Main Gym HVAC Replacement & Re-Roof Pleasant Valley High School Chico Unified School District Chico, CA 95926

DSA File No: 4-12

DSA Application No: 02-115458

Addendum No. 3 February 24, 2017

ADD3-A-1

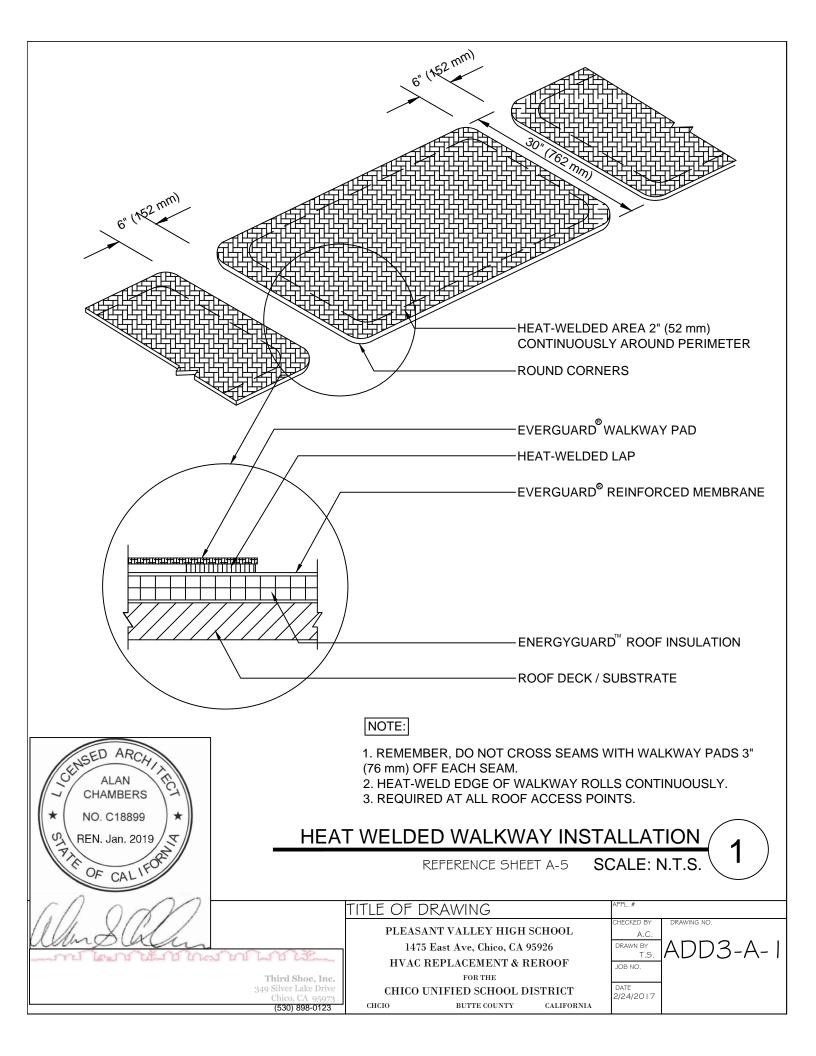
- 1. Sheet A-5 ROOF PLAN
  - a. See revised roof plan showing the layout and locations for the traffic walkway membrane. See also ADD3-A-1 heat welded walkway installation detail.

- 1. 07 54 00 THERMOPLASTIC MEMBRANE ROOFING
  - a. Specification 07 54 00 Add to item 2.05: H. Furnish manufacturer's standard traffic walkway membrane, as approved by manufacturer, of minimum 125 mil thickness and to be heat welded.

A-5

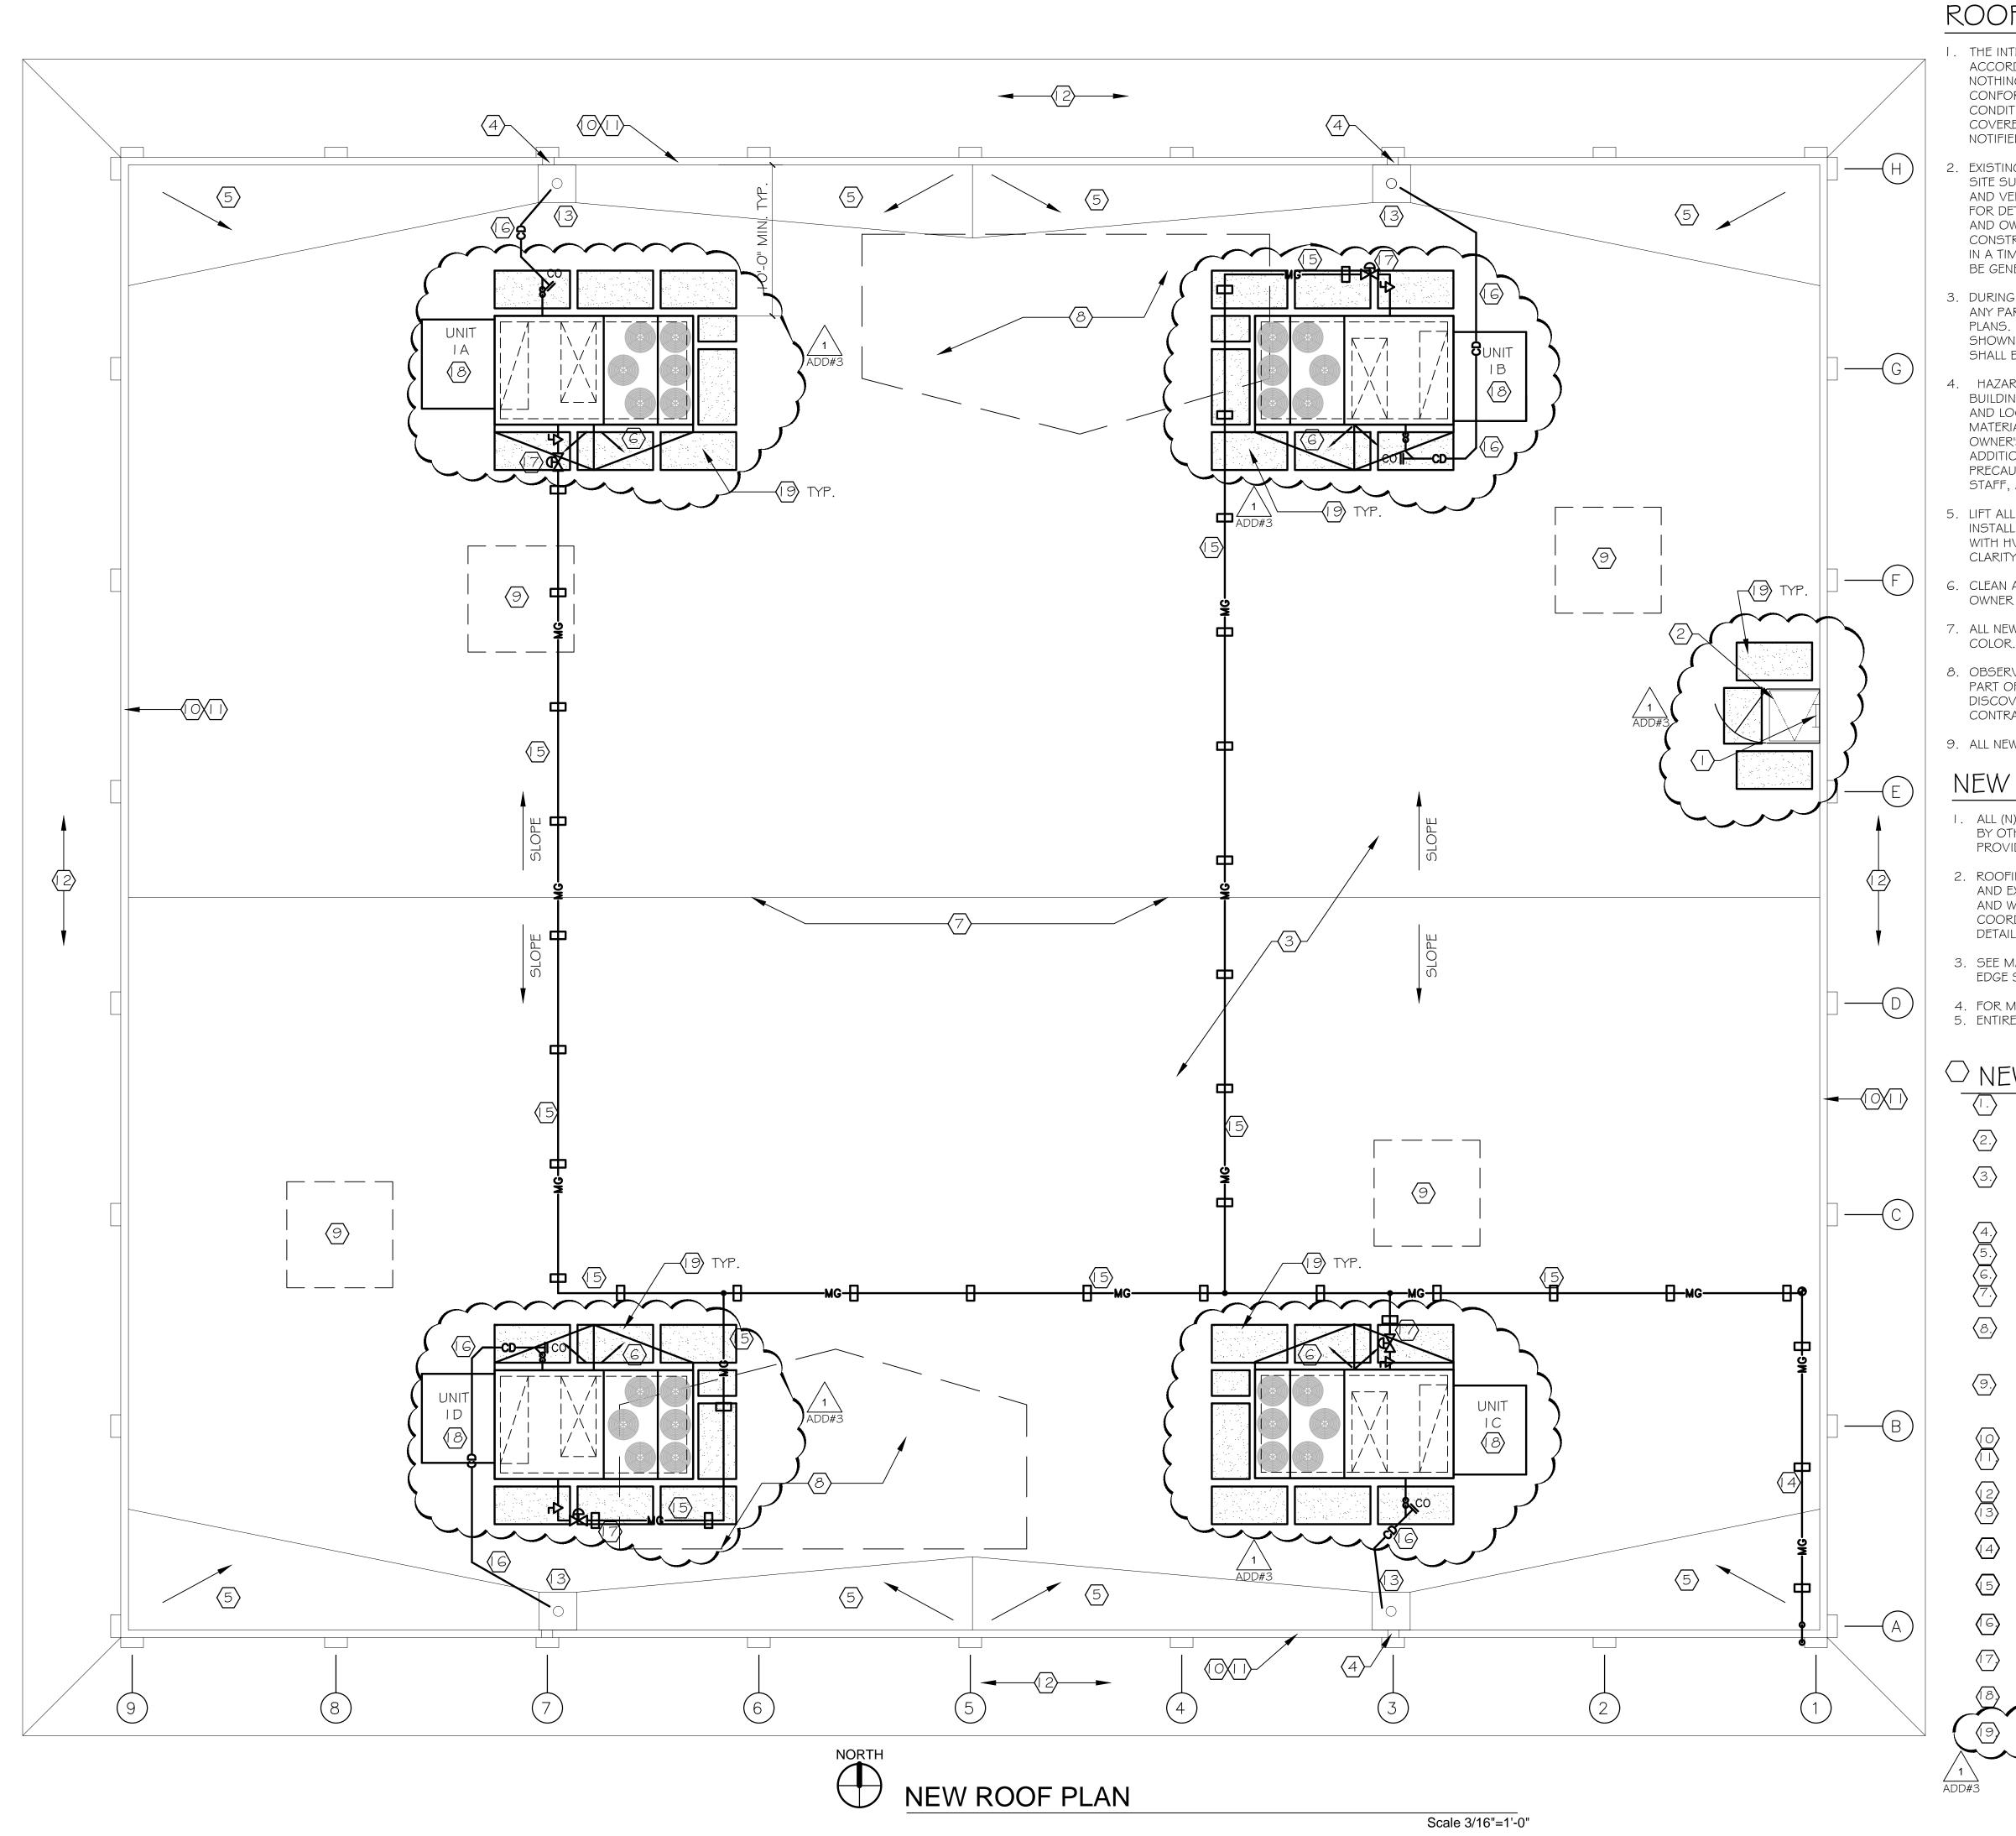
- (N) GAF EVERGUARD WELDED WALK PADS. SEE ADD3-A-I
